PRODUCT BULLETIN

Topic	iX4 Series Printer Improved Printing Adjustment Mechanism
Type	☐ New Product Launch
	☐ End of Life Notice
	■ New Product Feature

Add a Media-Guide near Platen

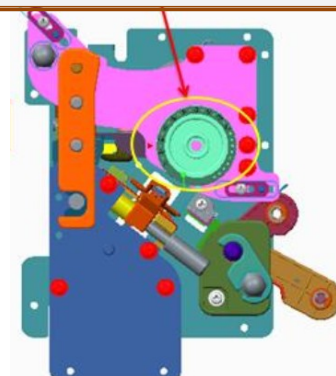
1. Added Media Guide to enhance the durability under high speed and loading for challenging industrial environment.

TPH module horizontal axis dial structure

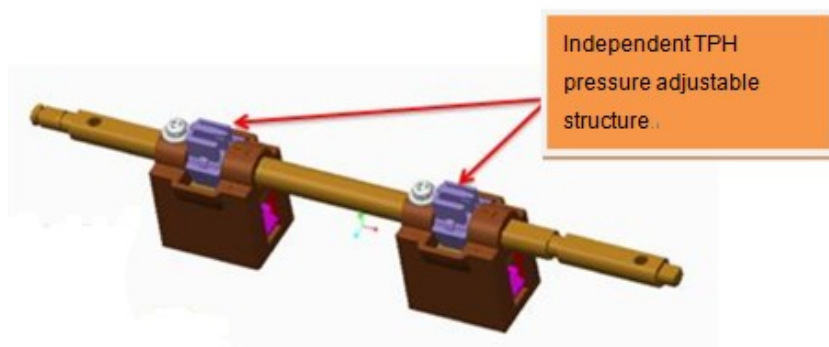
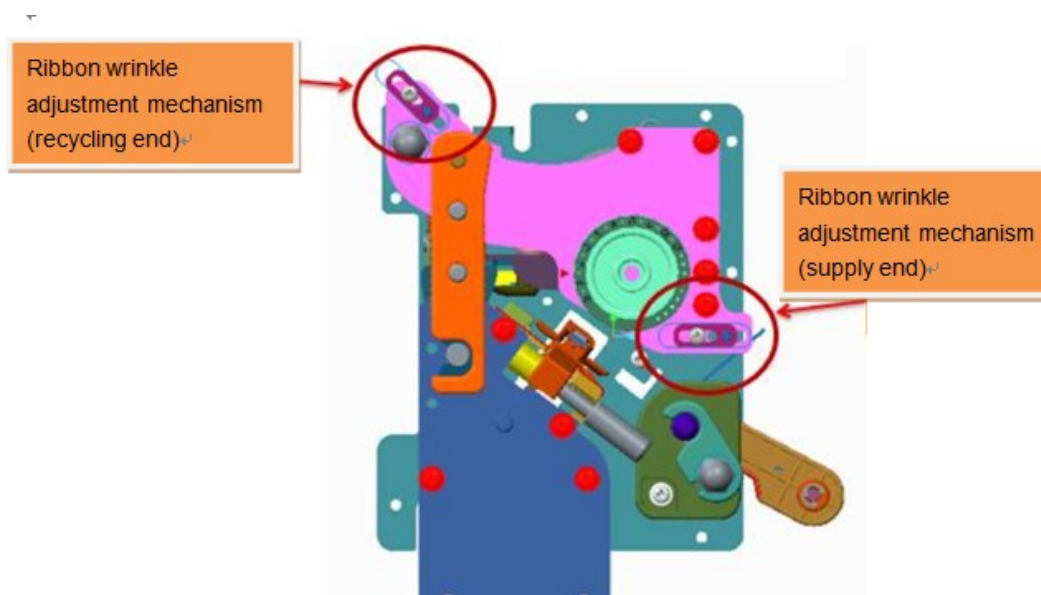
2. User friendly
    i. Added one visible and 10 stage of adjustable dial plate to improve the stability of TPH module.

ii.   TPH module : Add an 3 stage adjustable TPH pressure structure

iii.   Independent adjustable TPH pressure architecture
